[11] **Patent Number: Des. 417,632**

[54] **MASONRY FIXTURES**

UNITED STATES PATENT AND TRADEMARK OFFICE
CERTIFICATE OF CORRECTION

PATENT : Des. 417,632

FIG. 3

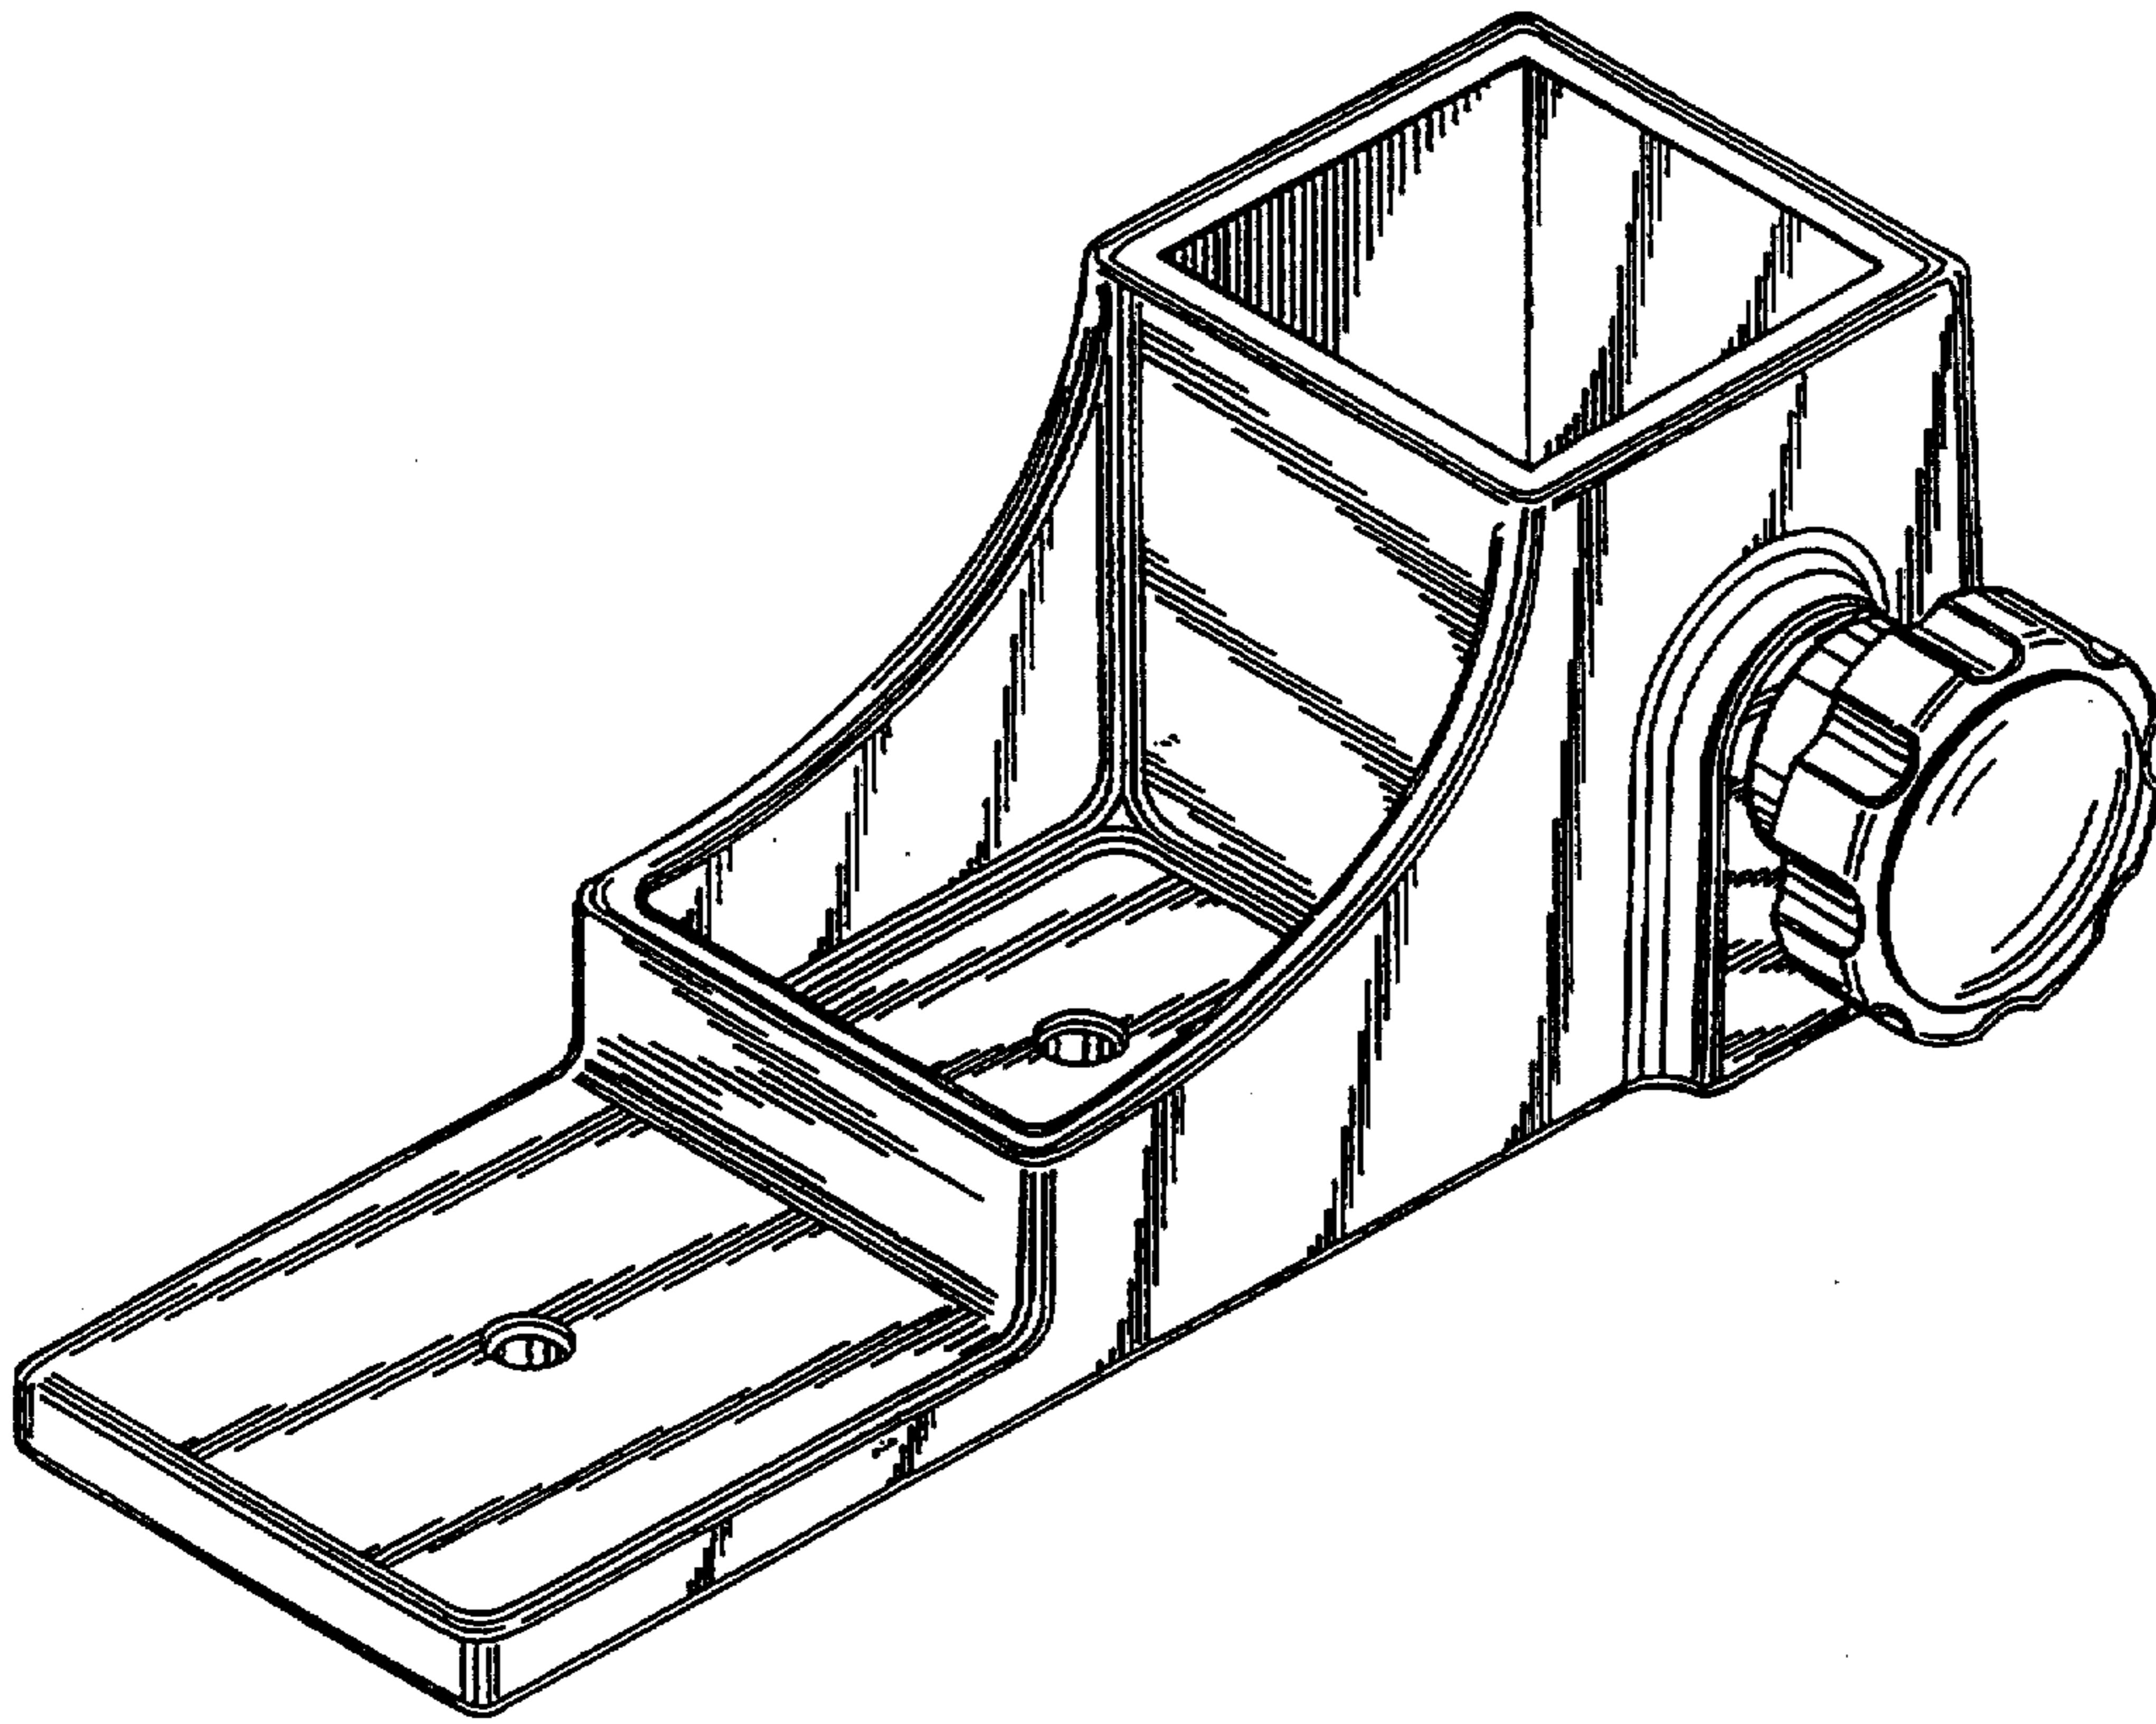
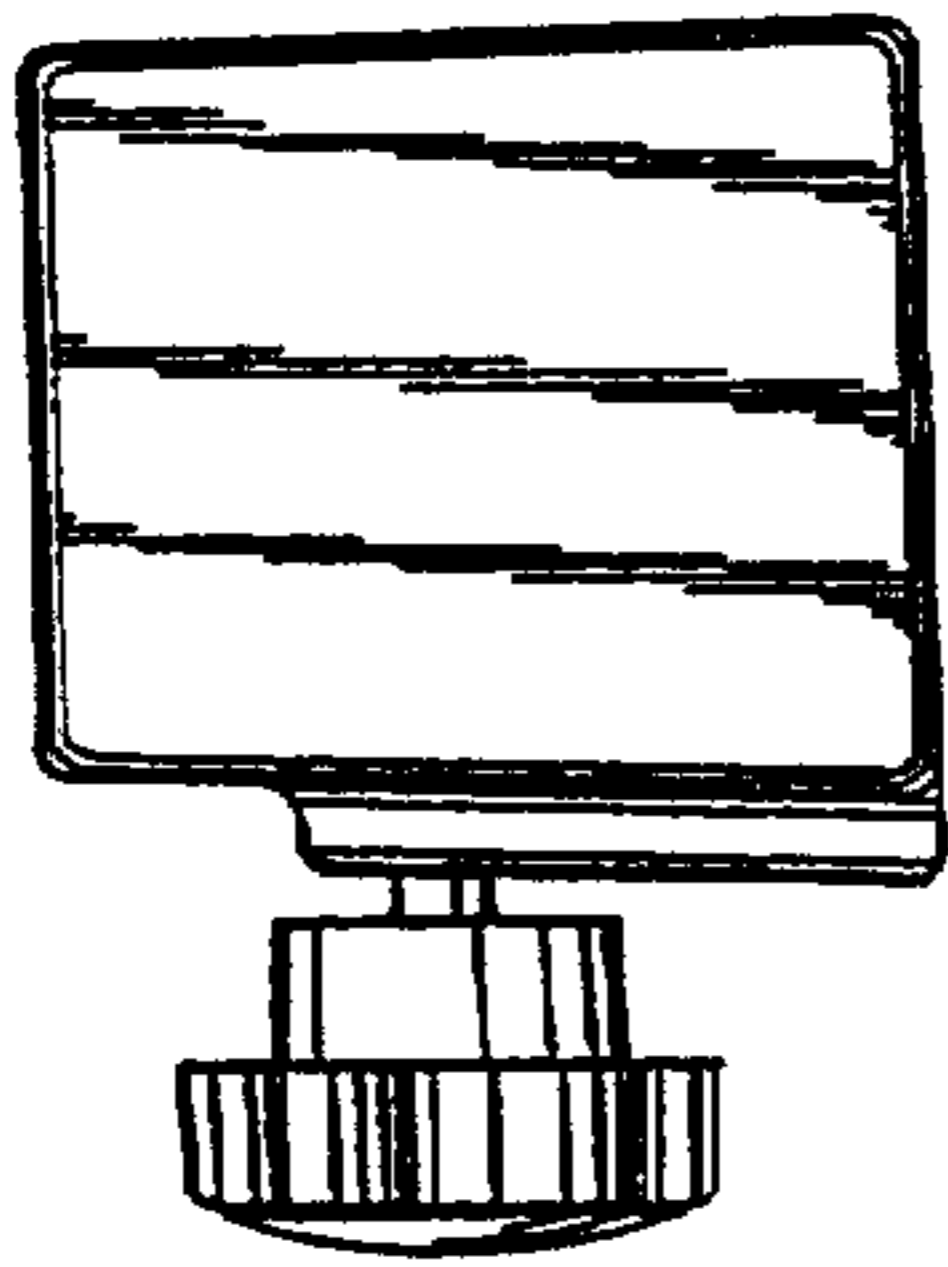
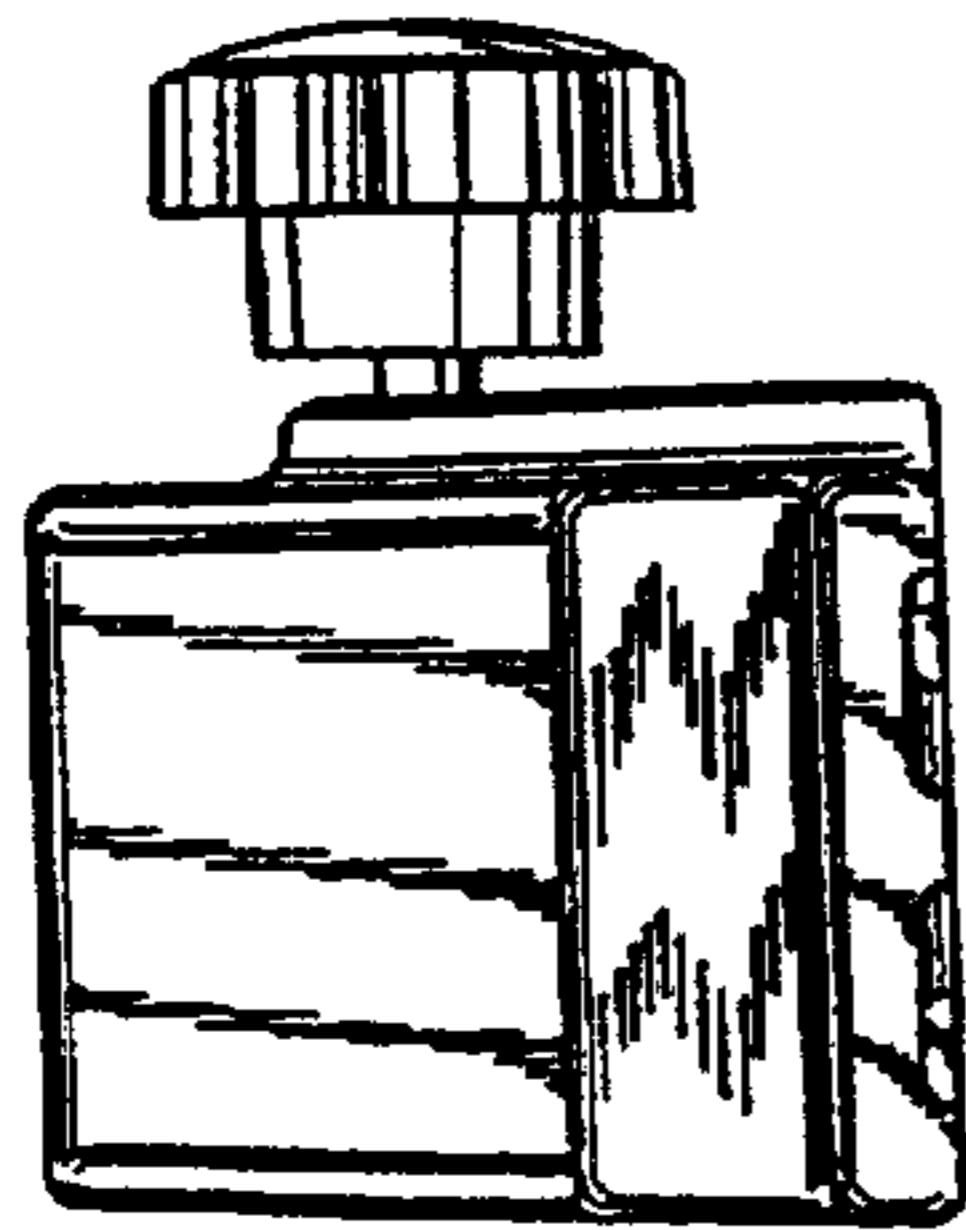
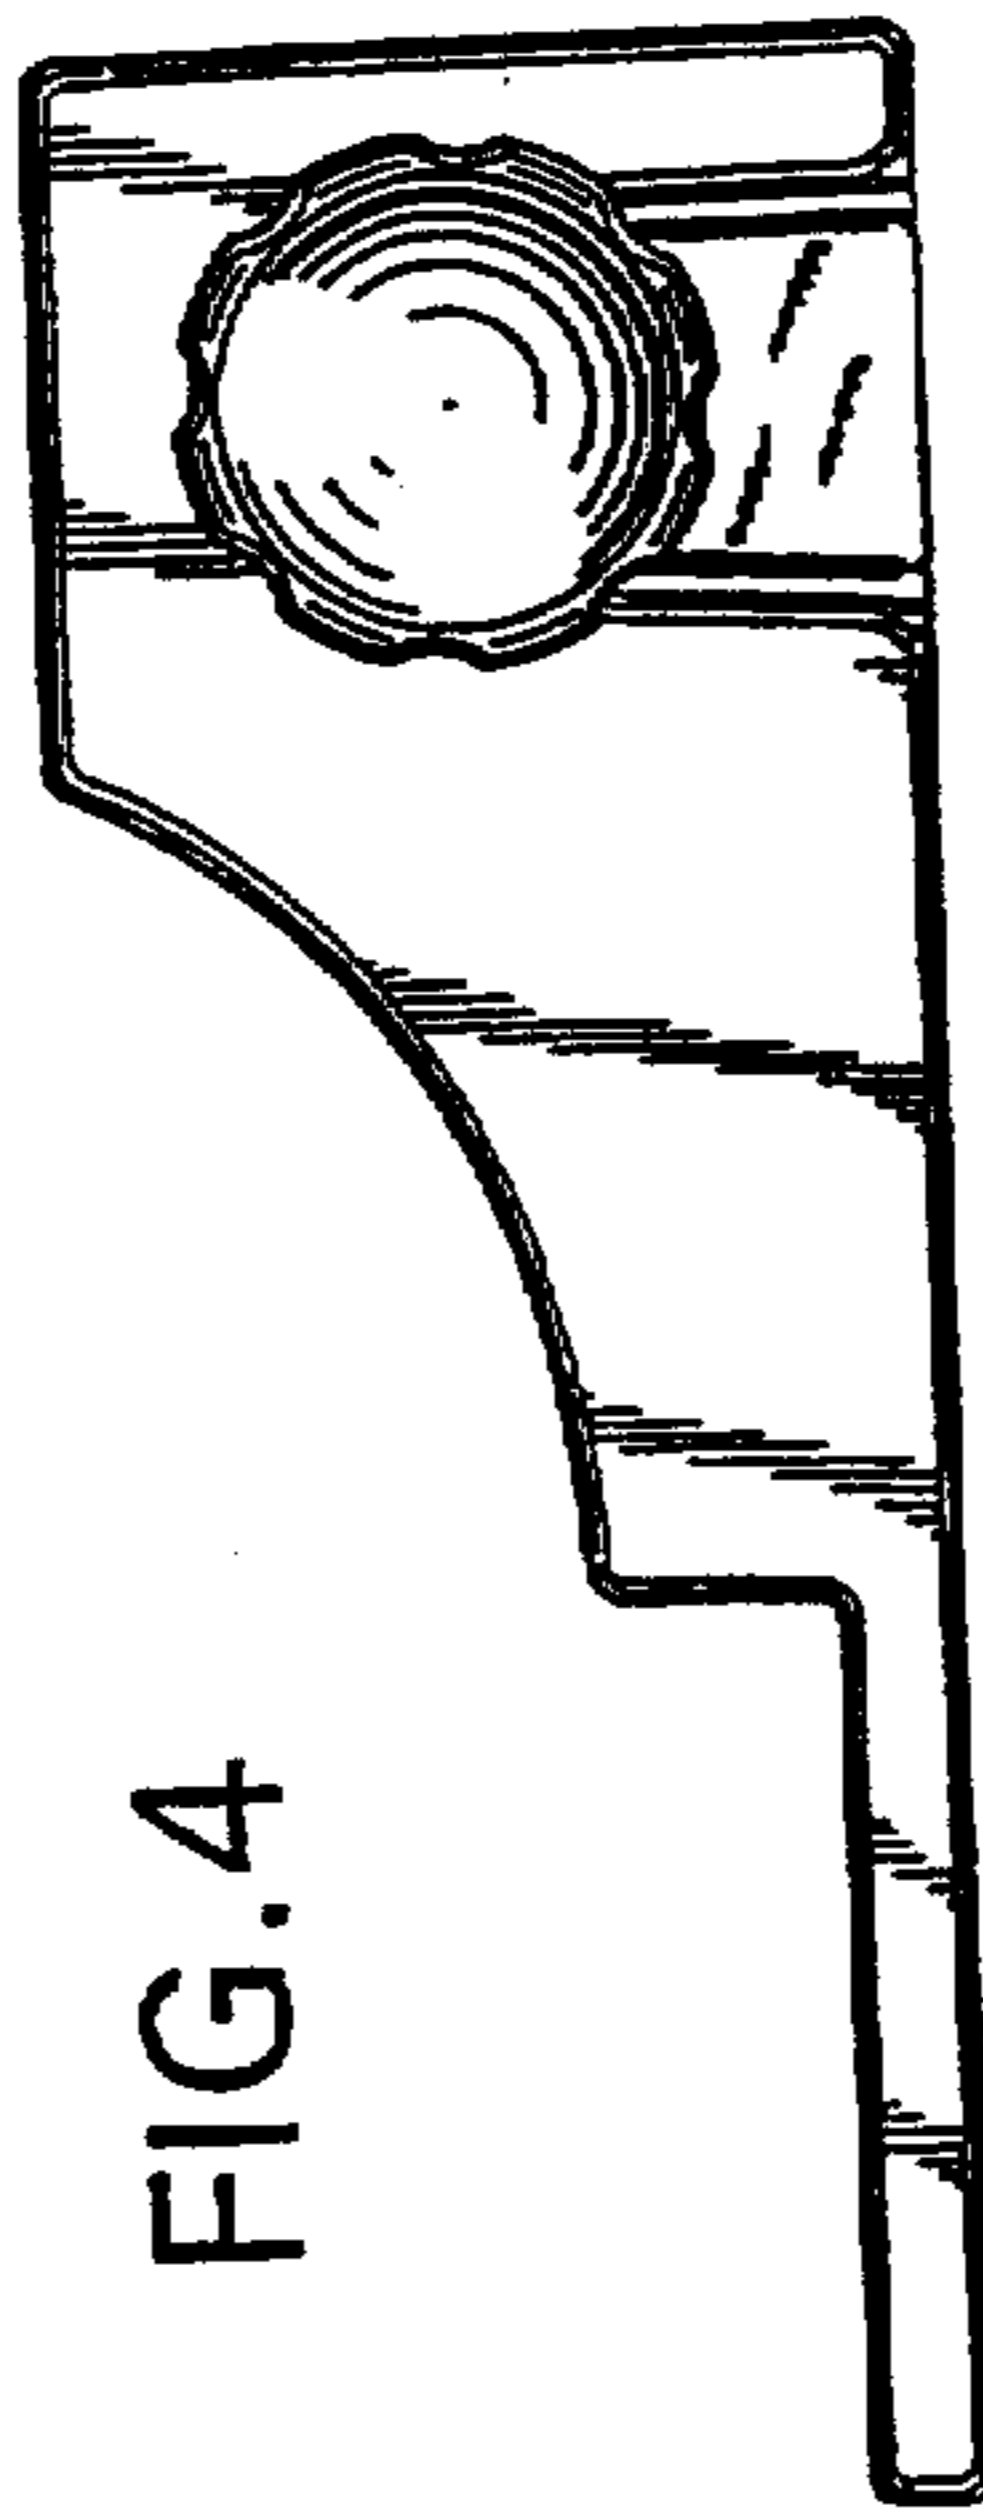
In the drawings, sheets 1 and 2, consisting of Figs. 1-7 should be deleted to be replaced with sheets 1 and 2, consisting of Figs. 1-7, as shown on the attached pages.
